October 31, 1986

The Commission has issued the enclosed Amendments Nos. 132 and 66 to Facility Operating Licenses Nos. DPR-57 and NPF-5, for the Edwin I. Hatch Nuclear Plant, Units Nos. 1 and 2. The amendments consist of changes to the Technical Specifications (TSs) in response to your application dated April 15, as supplemented July 25, and September 22, 1986.

GEORGIA POWER COMPANY
OGLETHORPE POWER CORPORATION
MUNICIPAL ELECTRIC AUTHORITY OF GEORGIA
CITY OF DALTON, GEORGIA
DOCKET NO. 50-321
EDWIN I. HATCH NUCLEAR PLANT, UNIT NO. 1
AMENDMENT TO FACILITY OPERATING LICENSE

ATTACHMENT TO LICENSE AMENDMENT NO. 132

FIGURE 3.11-1 (SHEET 8) MAPFAC_F

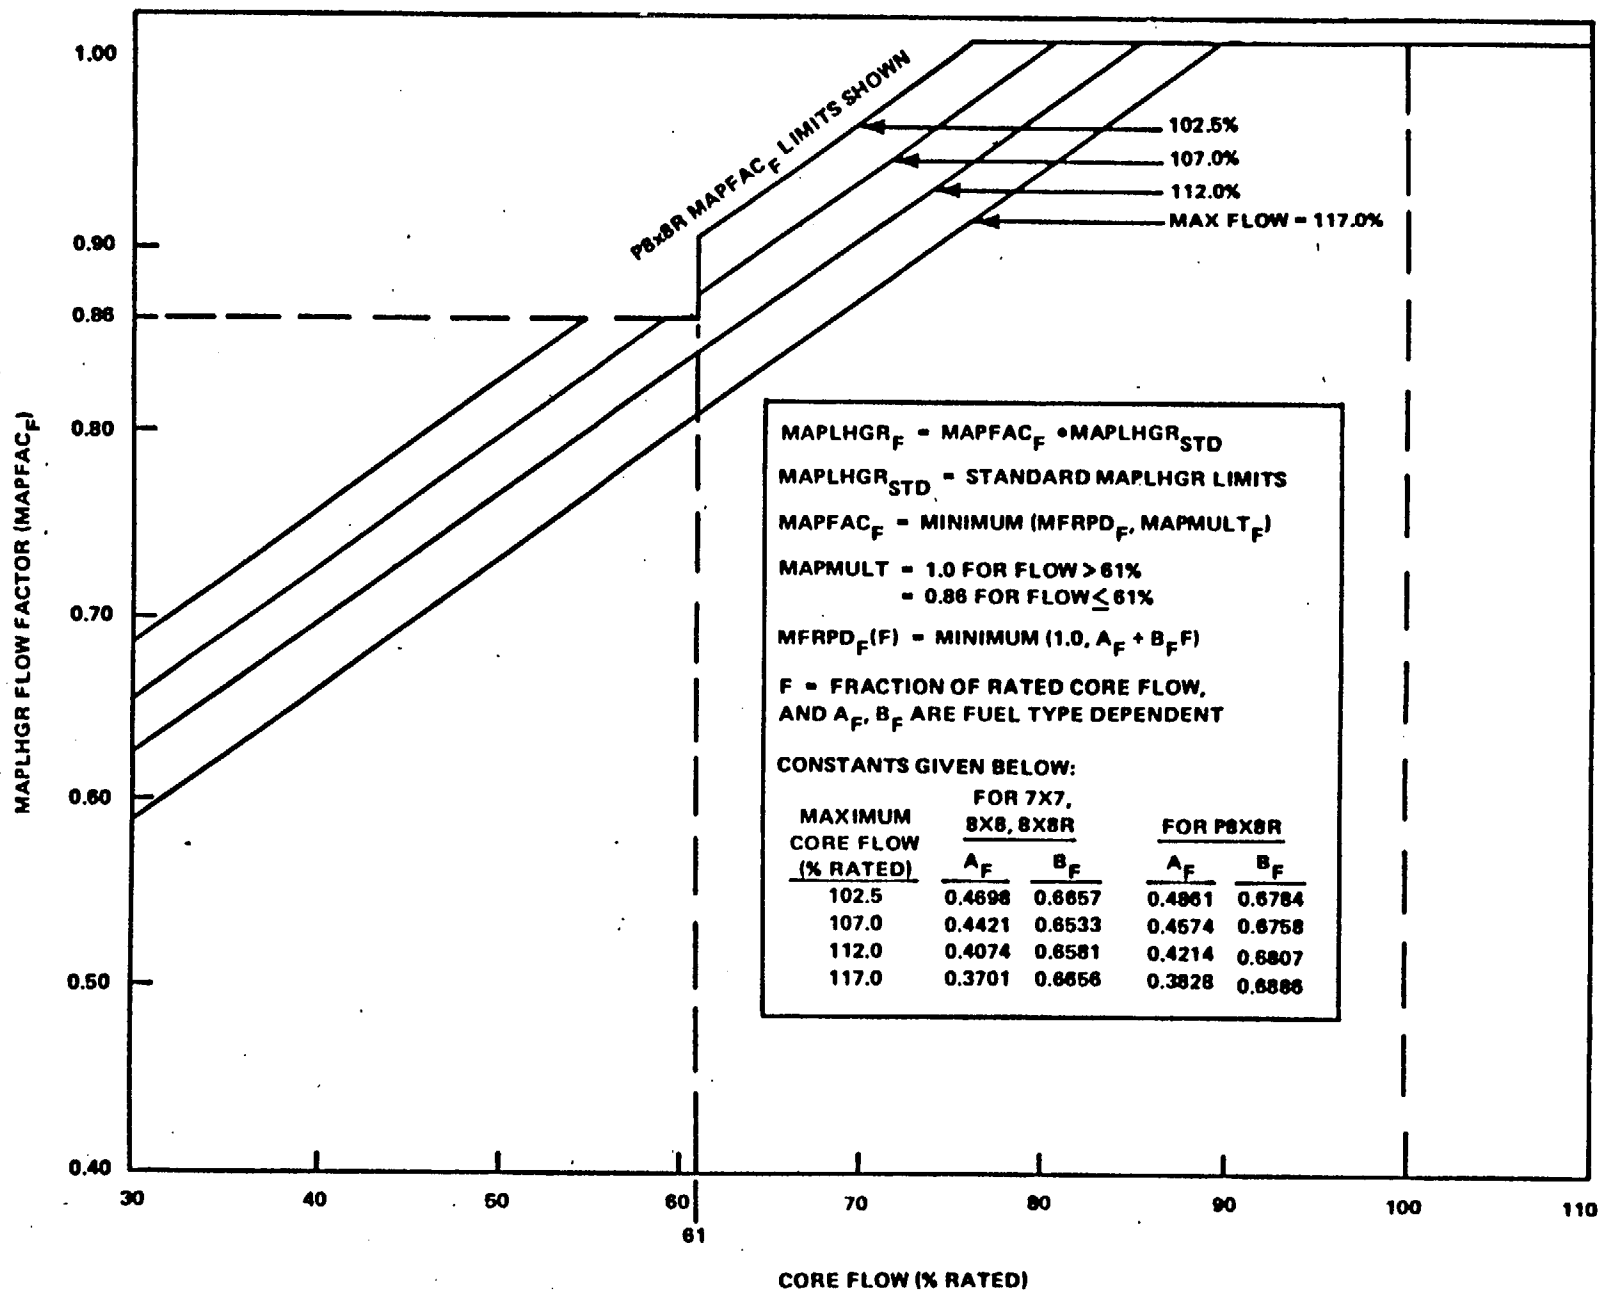
A flow dependent correction factor incorporated in to Figure 3.11-1 (sheet 8) is applied to the rated conditions APLHGR to assure that the 2200°F PCT limit is complied with during LOCA initiated from less than rated core flow. In addition, other power and flow dependent corrections given in Figure 3.11-1 (sheets 7 and 8) are applied to the rated conditions APLHGR limits to assure that the fuel thermal-mechanical design criteria are met during abnormal transients initiated from off-rated conditions.

FIGURE 3.2.1-12 MAPFAC_F

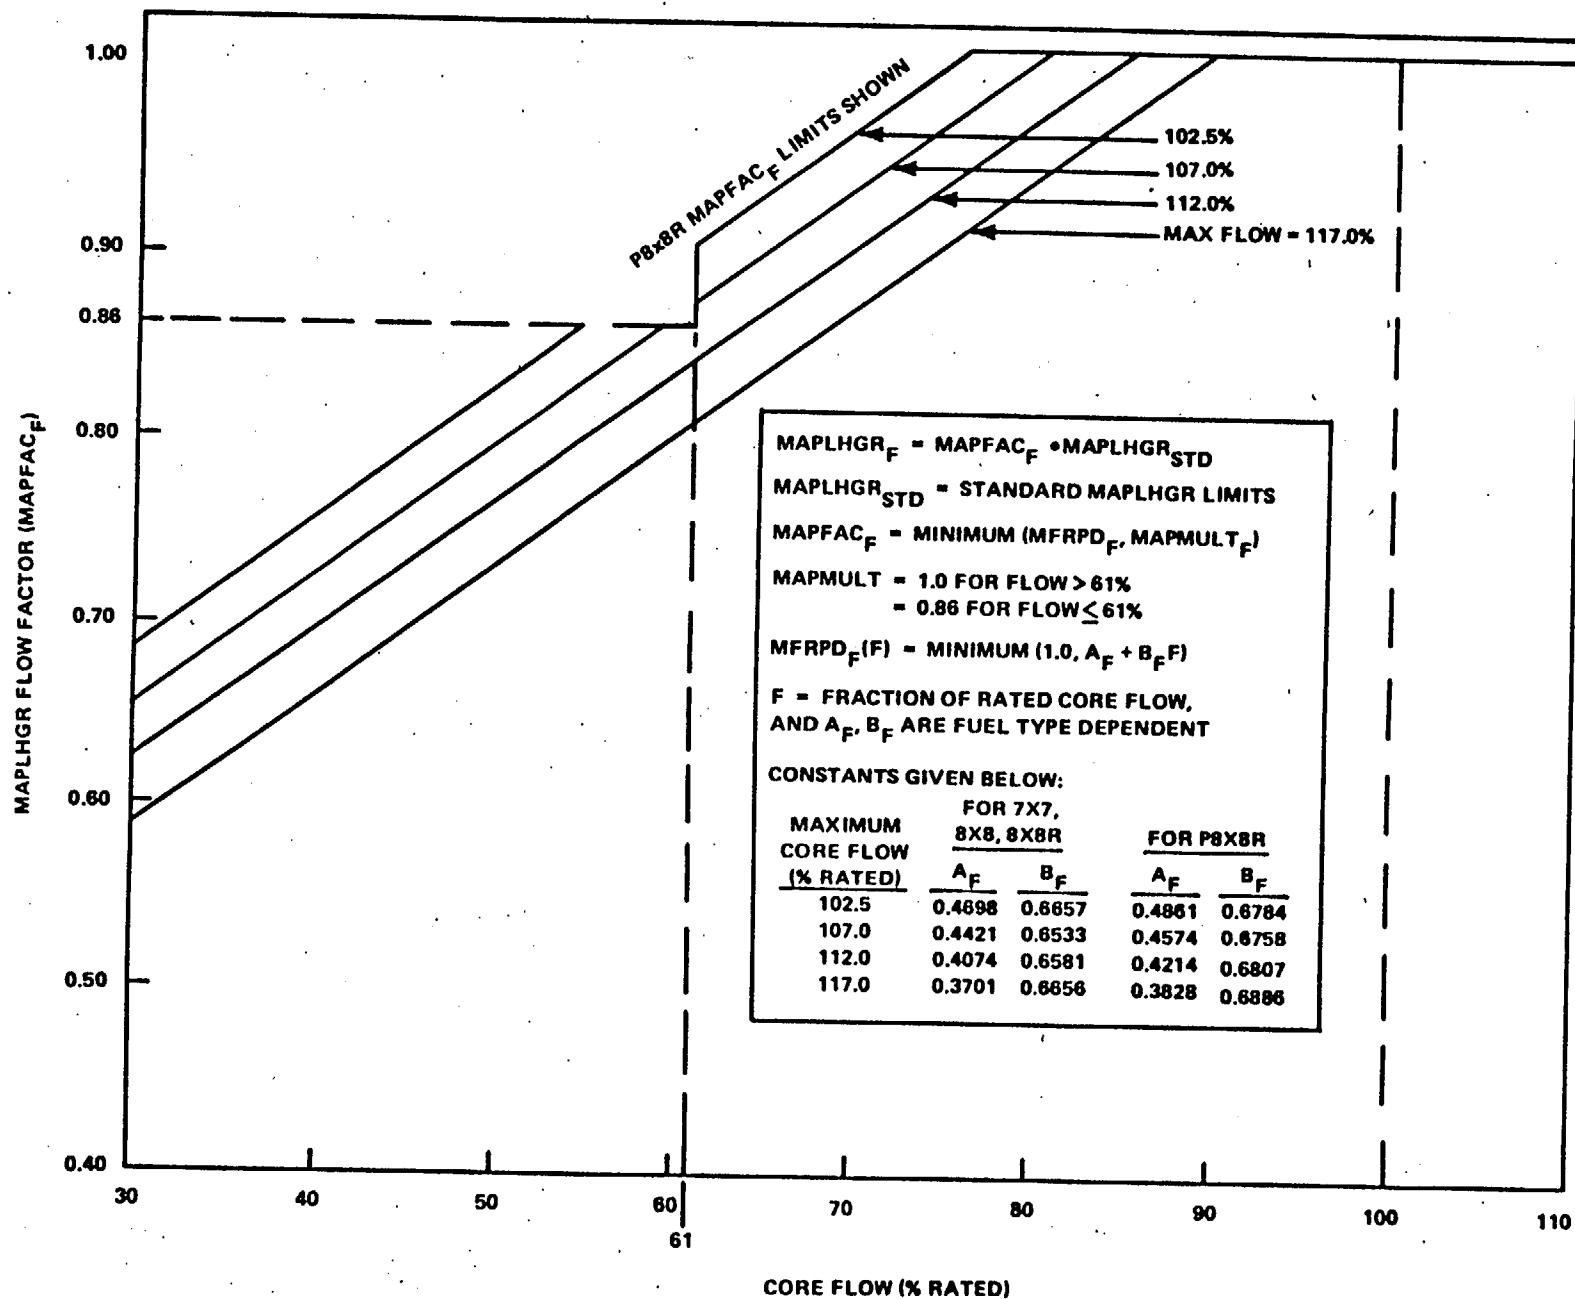
A flow dependent correction factor incorporated into Figure 3.2.1-12 is applied to the rated conditions APLHGR to assure that the 2200°F PCT limit is complied with during a LOCA initiated from less than rated core flow. In addition, other power and flow dependent corrections given in Figures 3.2.1-12 and 3.2.1-13 are applied to the rated conditions to assure that the fuel thermal-mechanical design criteria are preserved during abnormal transients initiated from off-rated conditions.

4. GPC proposed two editorial changes for Hatch 2 to correct a typographical error in Basis Table 3.2.1-1 and a title change to (new) Figure 3.2.1-12. There are also editorial changes to MAPLHGR figures for both units to specify which thermal limits apply to which channel thickness and to barrier or nonbarrier fuel. There are also some figure number changes because of the added MAPLHGR curves.
